RHODE ISLAND CONTRACT NO.2014-CH-028

**Apponaug Circulator By-Pass**

NOTICE TO PROSPECTIVE BIDDERS

ADDENDUM NO. 1 Prospective bidders and all concerned are hereby notified of the following changes in the Plans, Specifications, Proposal and Distribution of Quantities for this contract. These changes shall be incorporated in the Plans, Specifications, Proposal and Distribution of Quantities, and shall become an integral part of the Contract Documents.

CROSS SECTION AND SOIL MANAGEMENT AREA KEY PLAN

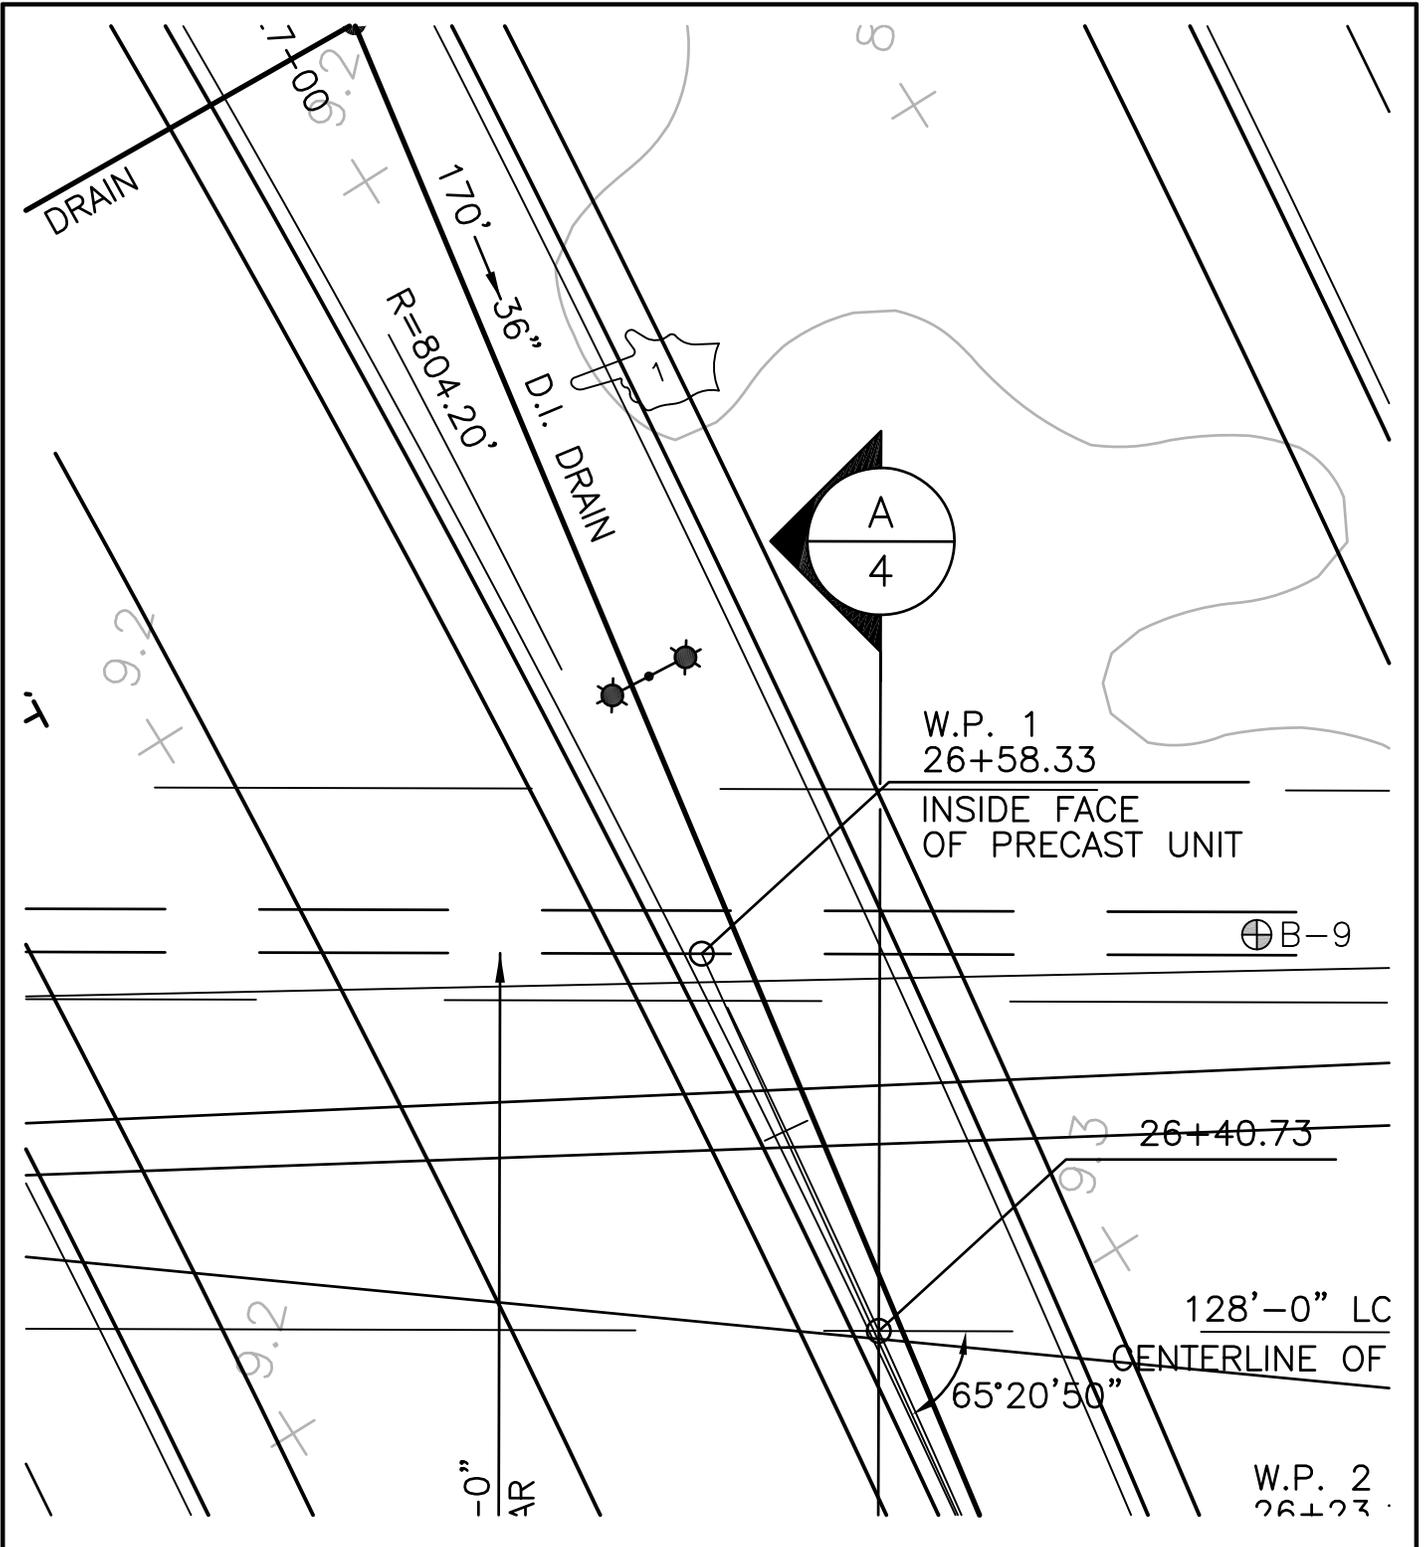
1. Volume 2 of 4 - Sheet No. 2 - Cross Section and Soil Management Area Key Plan  
Delete Sheet No. 2 in its entirety and replace it with revised Sheet No. 2(R-1) attached to this Addendum No. 1. The scale has been corrected.

**THREE SIDED BRIDGE FASCIA UNIT CONNECTOR DETAIL**

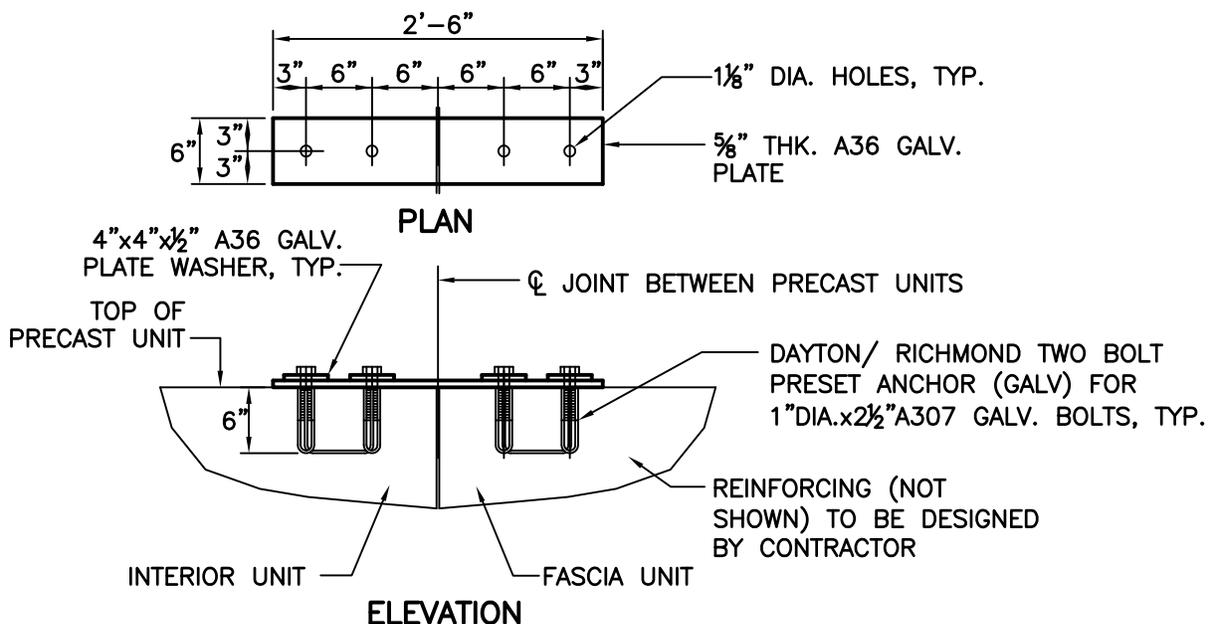
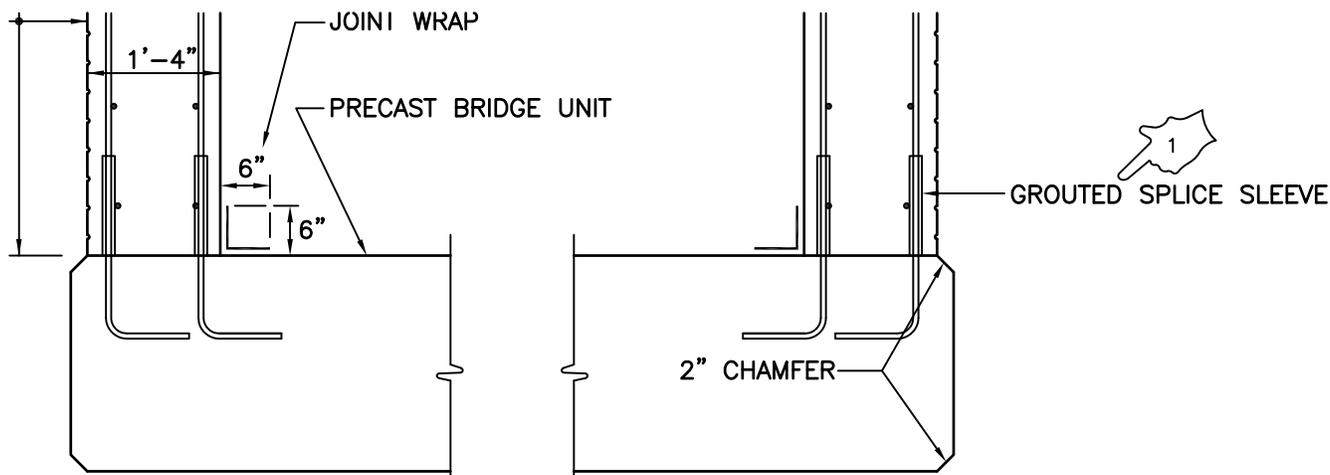
3. Volume 3 of 4 - Sheet No. 7 – Precast Bridge Details  
Revise Sheet No. 7 as shown on Sketch No. 2(R-1) attached to this Addendum No. 1. A detail has been added and the callout for the grouted splice sleeve has been revised.

**TYPICAL WALL SECTION**

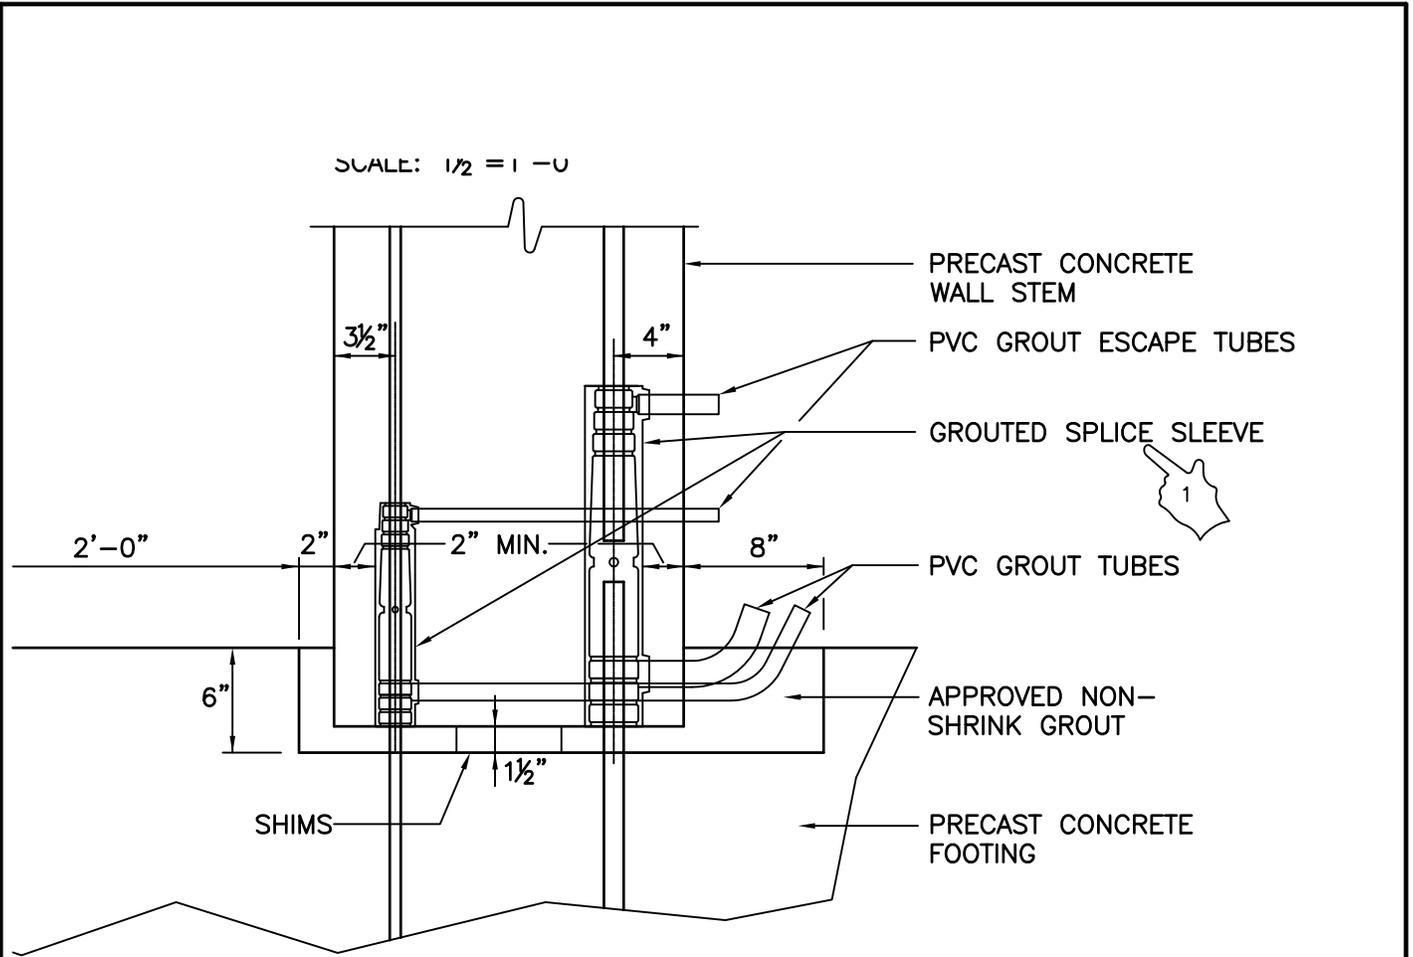
4. Volume 3 of 4 - Sheet No. 10 – Precast Wall Details-3  
Revise Sheet No. 10 as shown on Sketch No. 3(R-1) attached to this Addendum No. 1. The footing dimension has been revised and the callout for the grouted splice sleeve has been revised.

**TYPICAL WALL FOOTING KEY DETAIL**

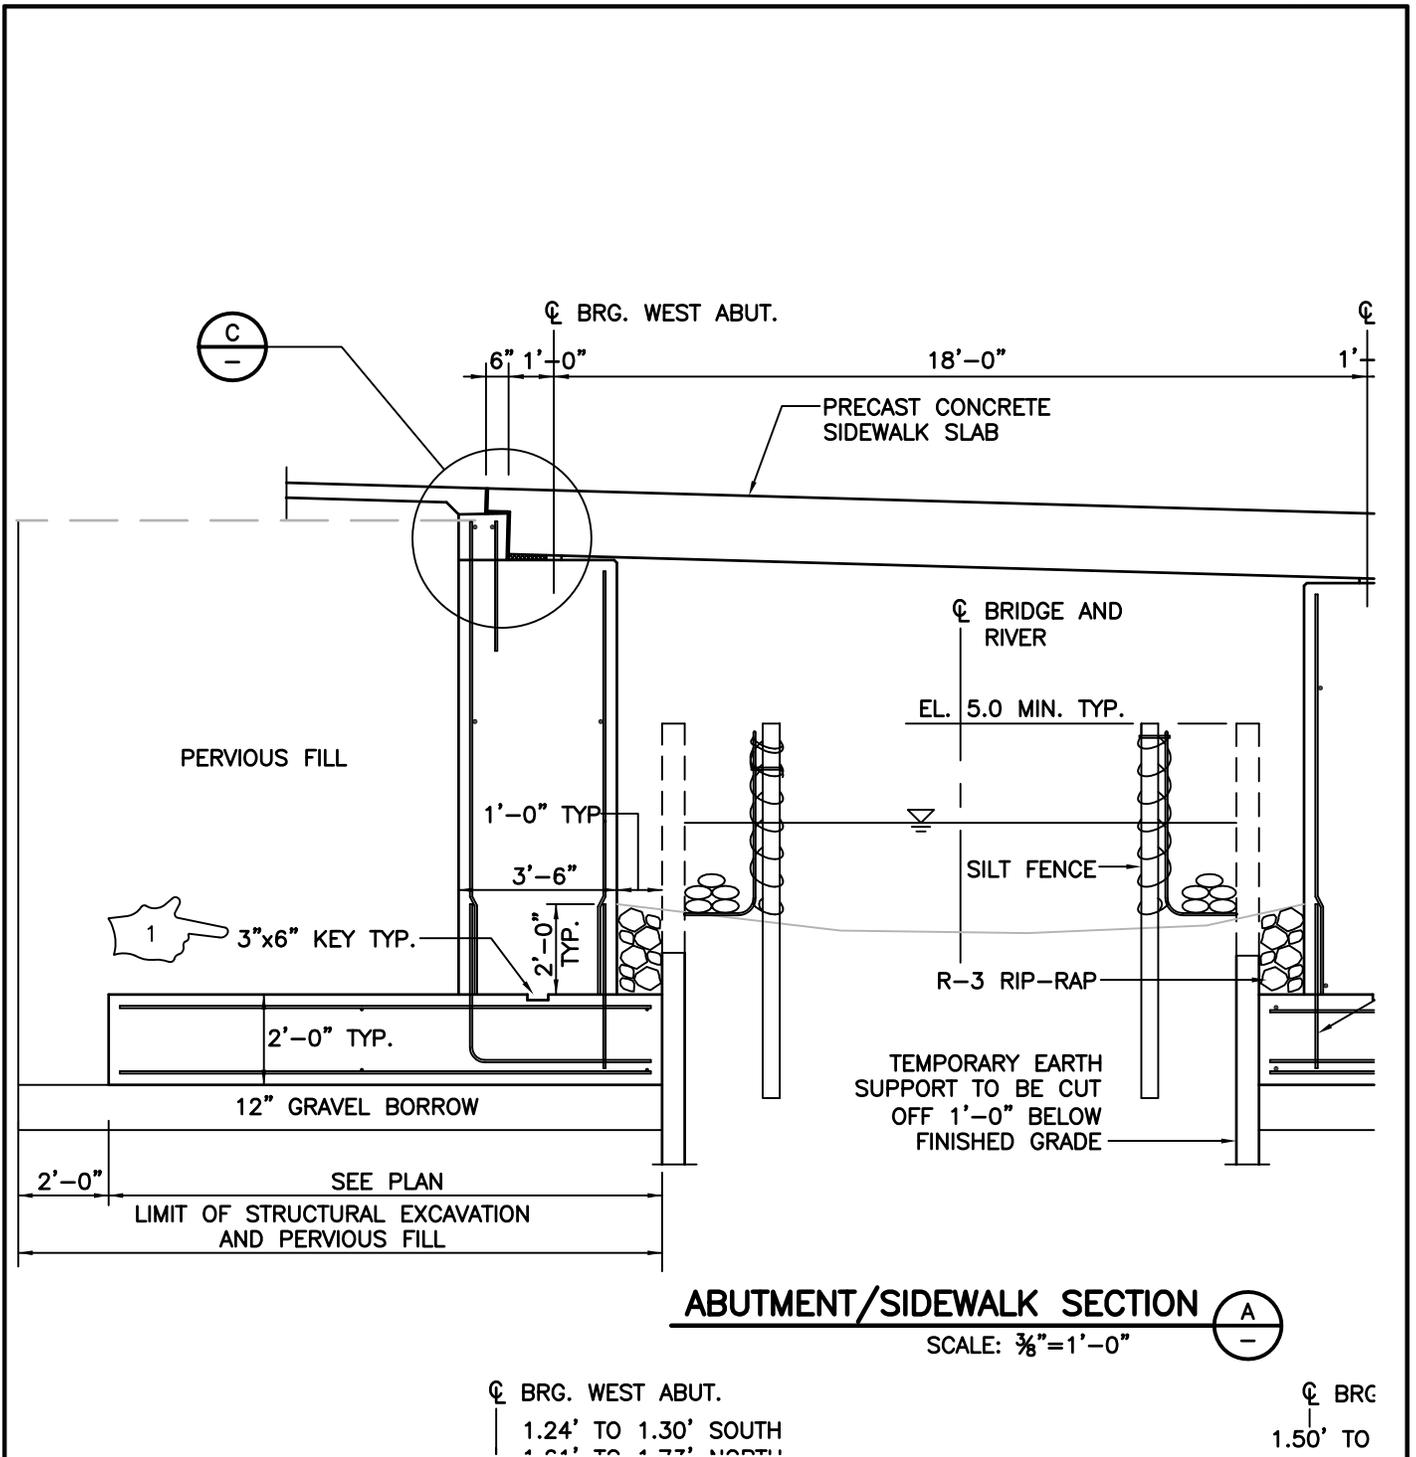
5. Volume 3 of 4 - Sheet No. 10 - Precast Wall Details-3  
Revise Sheet No. 10 as shown on Sketch No. 4(R-1) attached to this Addendum No. 1. The callout for the grouted splice sleeve has been revised.
